Docket Nos. 50-280
and 50-281 ✓

Licenses Nos. DPR-32
and DPR-37

Change No. 13

4.15 AUGMENTED INSERVICE INSPECTION PROGRAM FOR HIGH ENERGY LINES
OUTSIDE OF CONTAINMENTApplicability

MAIN STEAM AND FEEDWATER LINES - UNIT 2
 SURRY POWER STATION
 UNITS 1 AND 2

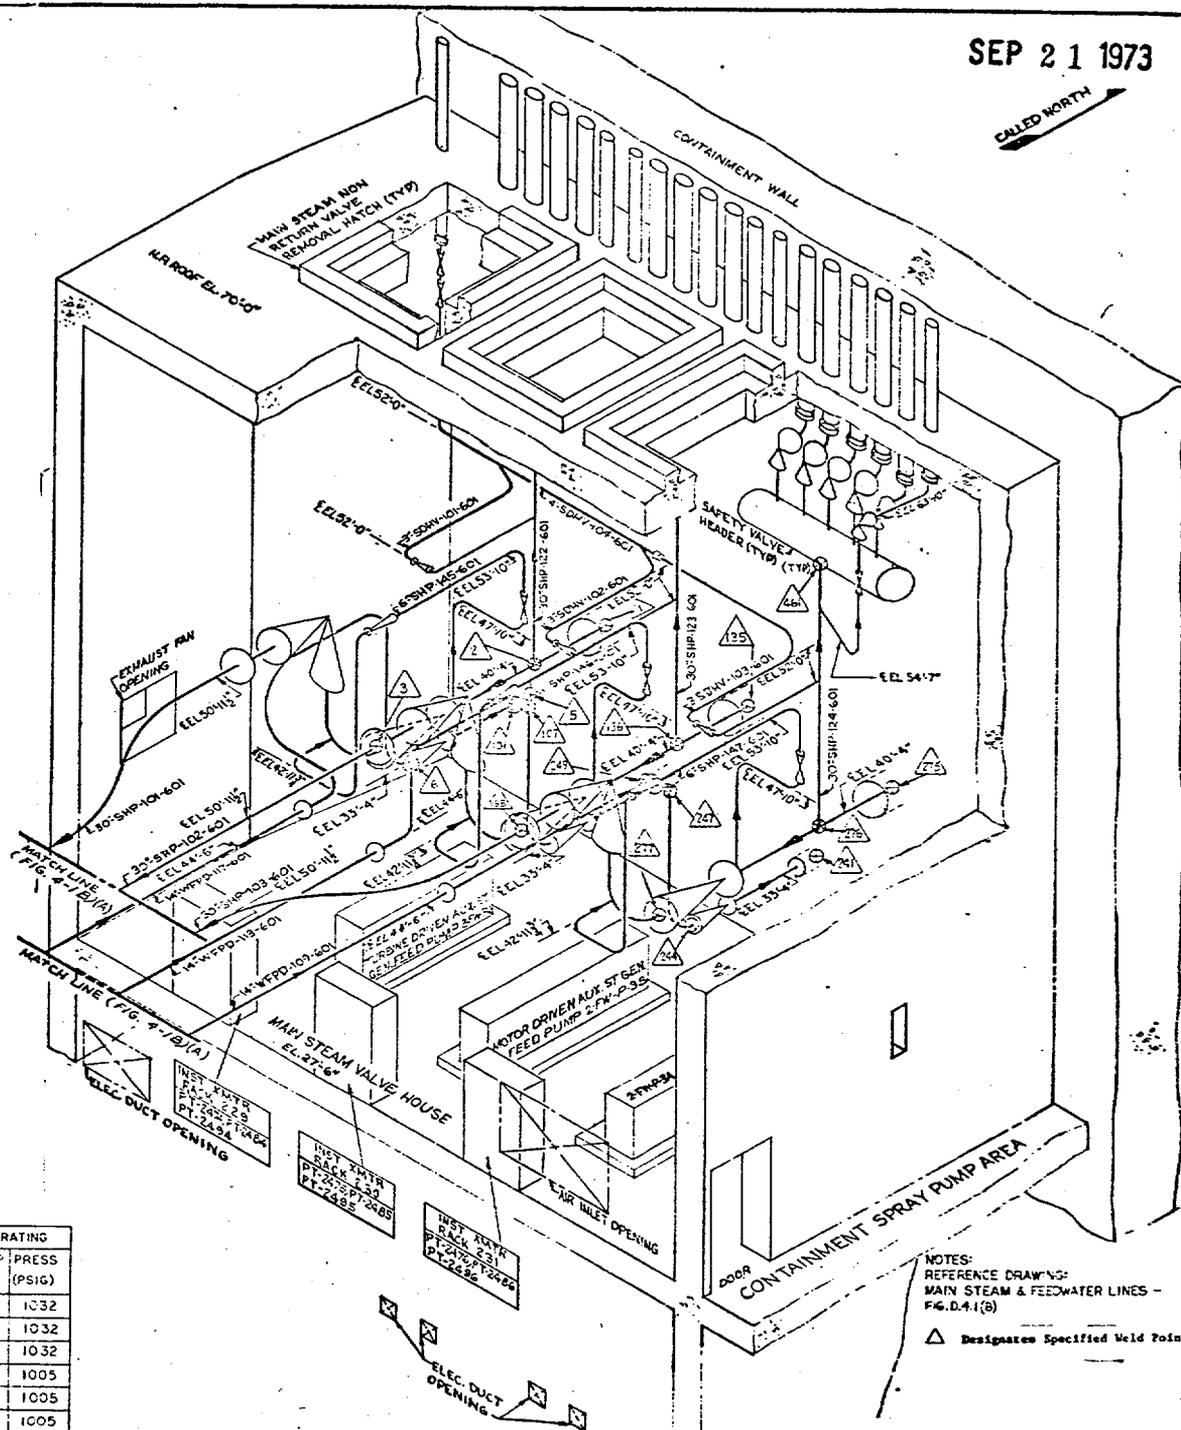
- A. For the 20 welds identified in TS Figure 4.15:
 1. At the first refueling outage period a volumetric examination shall be performed with 100 percent inspection of welds in accordance with the requirement of ASME Section XI Code, Inservice Inspection of Nuclear Power Plant Components, to

3. Examinations that reveal unacceptable structural defects in a weld during an inspection under TS 4.15.A.2 shall be extended to require an additional inspection of another 1/3 of the welds. If further unacceptable defects are detected in the second sampling, the remainder of the welds shall be inspected.

4. In the event repairs of any welds are required following any examination during successive inspection intervals, the inspection schedule for the repaired welds will revert back to the first 10 year inspection program.

- B. For all welds other than those identified in TS Figure 4.15:
 1. Welds in the main steam lines including the safety valve headers and in the feedwater lines in the main steam valve house shall be examined in accordance with the requirements of subsection ISC 100 through 600 of the 1972 Winter Addenda of the ASME Section XI Code.
